**Florida
Power**
CORPORATION

February 1, 1988
3F0288-02

Subject: Crystal River Unit 3
Docket No. 50-302
Operating License No. DPR-72
Additional Information - Diesel Generator Loading

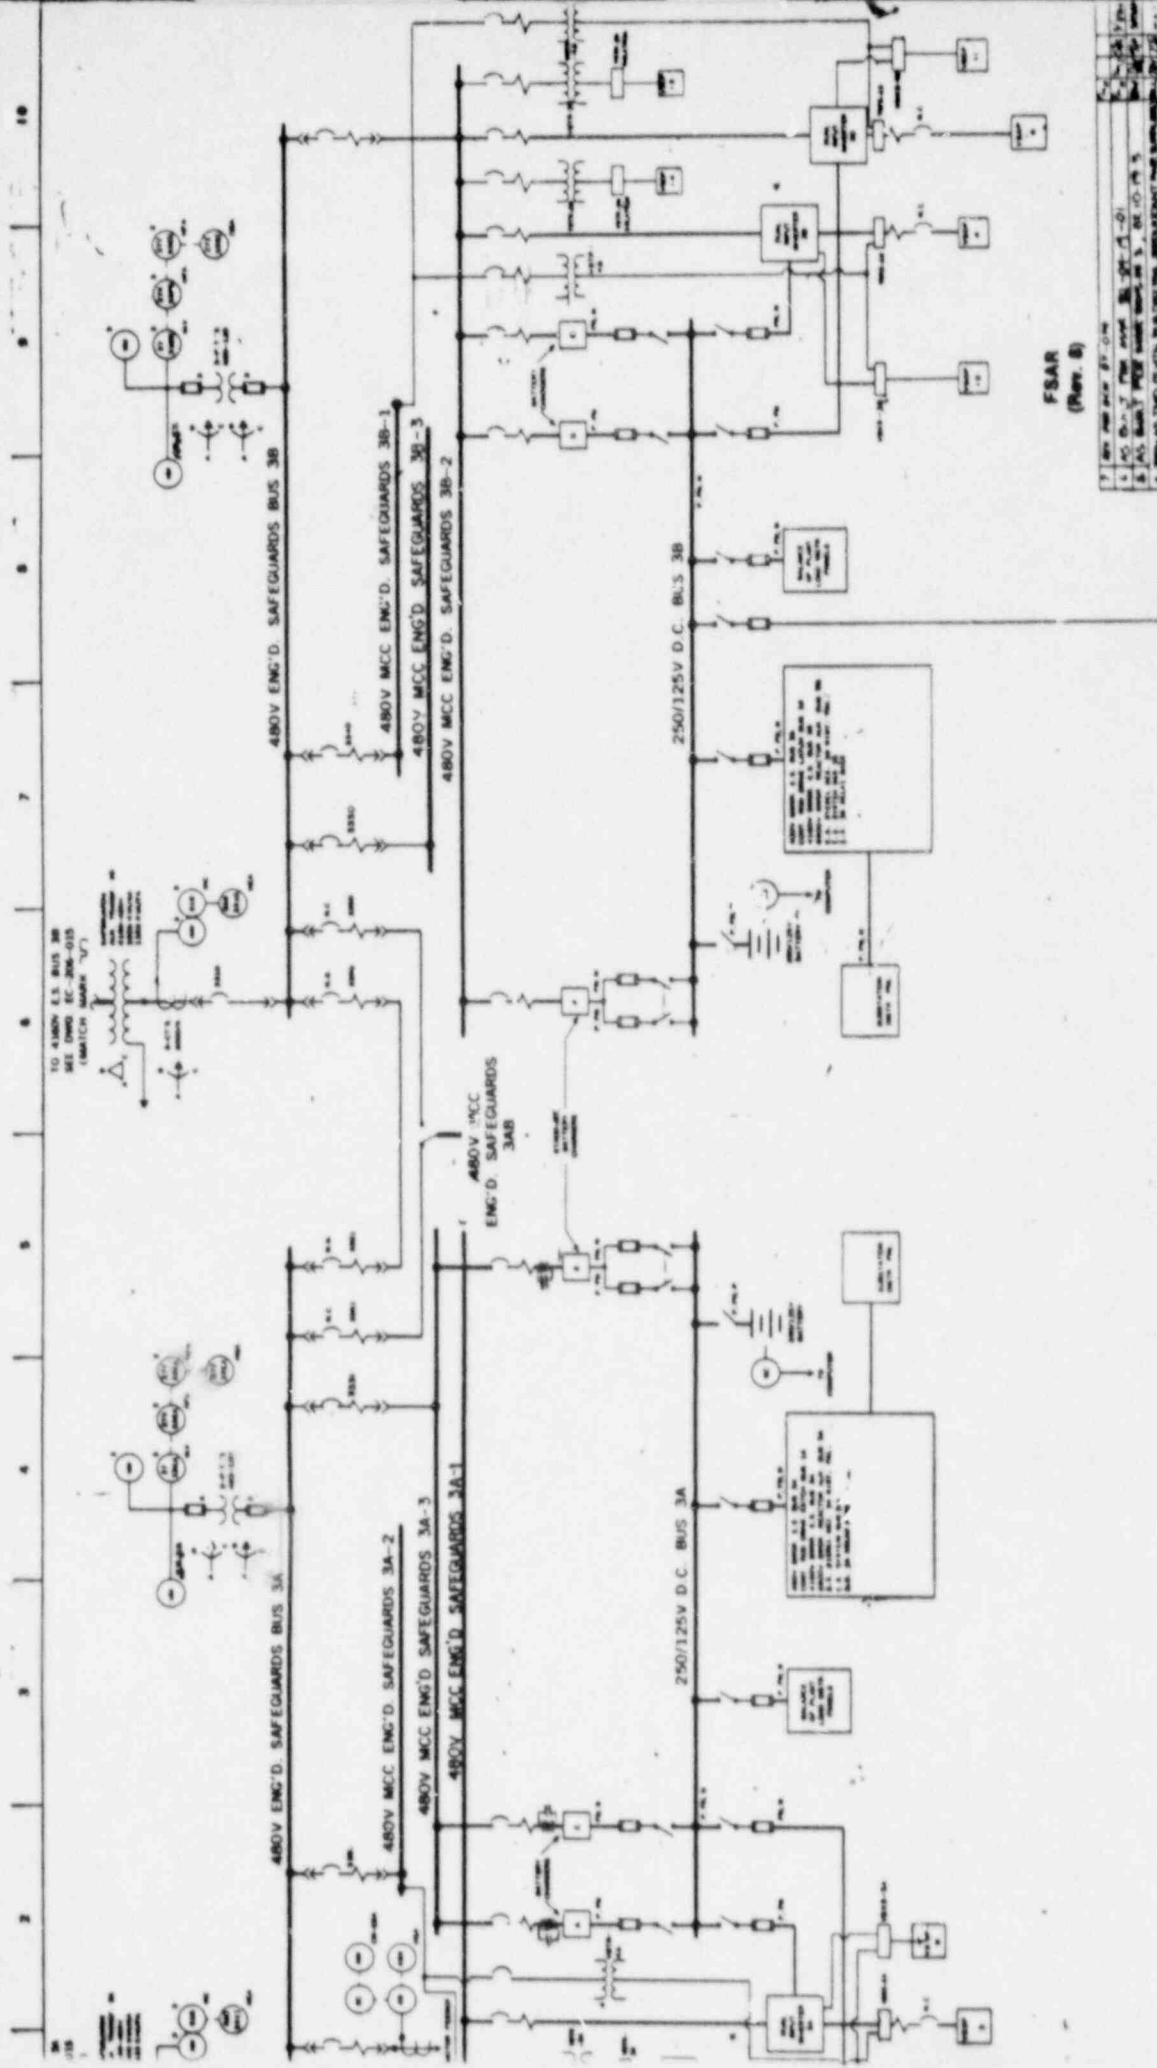
QUESTION 7: With regard to tripping the Class 1E battery charger, what is the battery voltage (terminal and at the load) at its lowest point before the charger(s) are reconnected. What provisions are there to ensure that they are reconnected. What is your basis for assuming that the inverter loads will remain functional when connected to the d.c. bus.

RESPONSE 7: Battery chargers 3A, 3C and 3E each have an output capability of 125V, 200 amps. Battery charger 3E is a standby for either 3A or 3C. This is accomplished via mechanical interlock that allow charger 3E to replace either 3A or 3C.

The modification to battery chargers 3A, 3C and 3E provides a control scheme which trips the battery chargers under a condition of a Loss of Offsite Power coincident with ES actuation. This is accomplished by connecting a contactor in the power circuit of each charger between the charger and MCC feeder breaker (see the attached drawing). This control scheme will allow the operator to reconnect the chargers administratively after approximately 30 minutes. The battery voltage at the end of this time period (30 minutes after tripping the chargers) has been analyzed to be 109 volts.

The inverters used at CR-3 have their primary source of power as ES 480V/AC from Motor Control Centers which are fed from the EDG. The battery/chargers serve as an alternate source of power for the inverters. The primary source of power is AC converted to DC and is held at a slightly higher DC voltage level than the alternate source DC. When primary source is lost, power will automatically be supplied from the alternate source DC and an alarm will be sounded in the Control Room alerting the operator that the inverters are on alternate source. When primary source AC power is reestablished, the inverters automatically revert back to primary source because of its slightly higher converted DC voltage level. There is no operator action involved in transfer between primary and alternate source.
